AGENDA ITEM	13.(h)
MEETING	October 15, 2025
DATE

SUBJECT: CHANGE ORDER (COR) NO. 03 TO EF BRETT &

COMPANY INC FOR CONSTRUCTION SERVICES FOR FAIRFIELD CAMPUS BUILDING 1600 MODERNIZATON

BUILDING 1600 MODERNIZATION

ELECTRICAL FIRST FLOOR POWER PLAN

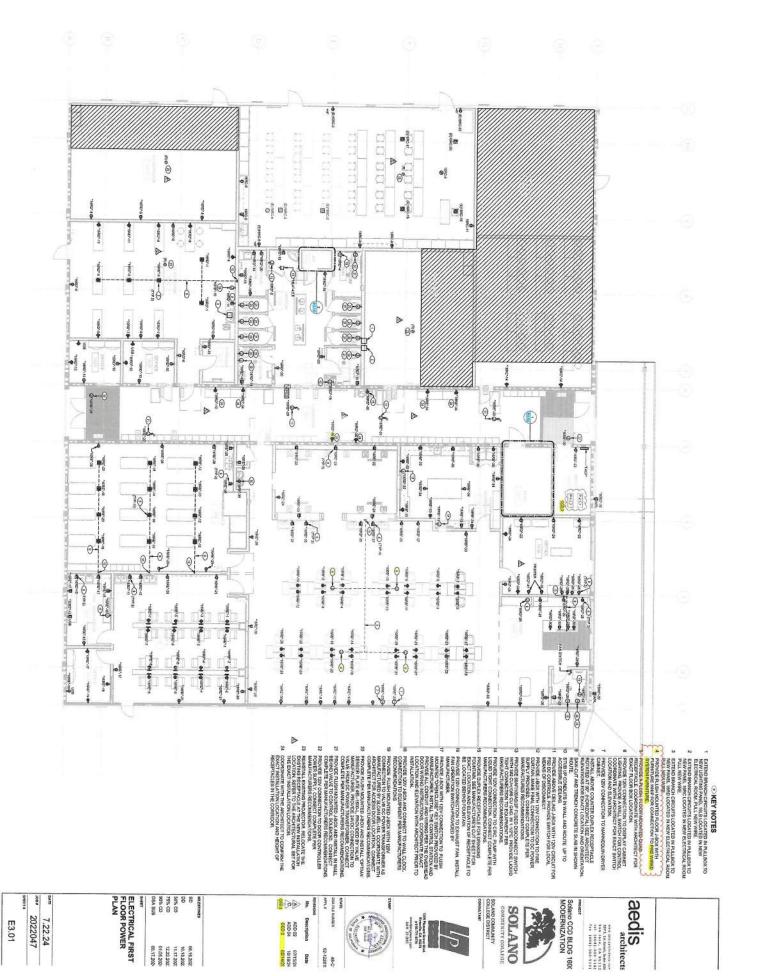
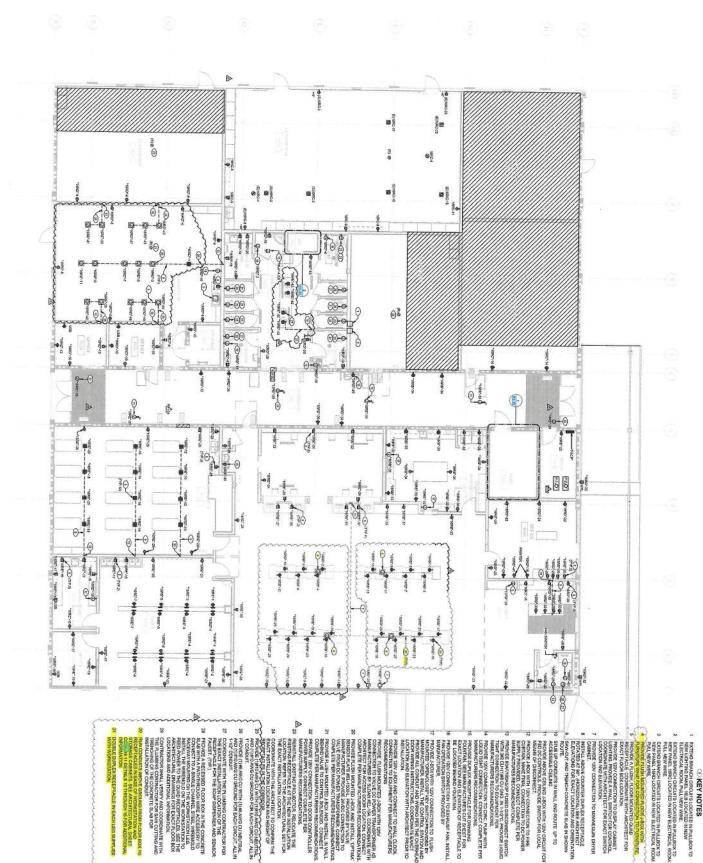
SHEET E3.01

Janitor-Restrooms: \$1,676.66

- Furnish and install four (4) double duplex receptacles at Restrooms and route conduit & circuitry back to panel 16RE-42. Panel terminations and testing included.

Classroom 1626: \$46,916.21

- Furnish and install ten (10) additional floor boxes in classroom 1626. Scope includes underground raceway and circuitry to nearest wall location indicated and then transition to overhead conduit/circuitry to be routed back to panels indicated. Of the 10 new floor boxes, 9 of them will require new circuits to be added more than what was previously included in this classroom.

- Credit (7) wall receptacles that were replaced by floor boxes noted above in room 1626.
- (14) of the (15) Floor boxes included in new design for classroom 1626 are indicated to be a floor box that will then require above ground connection to furniture. Added surface raceway, conductors and connection required. (10) of these (14) locations are included in the (10) noted above. (4) of the (14) were already noted to be floorboxes but previously were indicated to be floorboxes with outlet only and now will require the added conduit nipple, junction box, surface metal wiremold raceway, and double duplex receptacle per sheet A301a Details 1-3.

Lobby 1602: \$15,263.13

- Furnish and install surface mounted conduit, wire and boxes under desk furniture provided by others. Previous drawing iteration indicated single point connection of a power whip from floor box only with the remaining electrical connections to be internal to furniture and provided by others. Impact is to 30 locations. Cost of added receptacles is not included in this PCO and should be provided with the furniture as noted per sheet E3.01, Note 31.
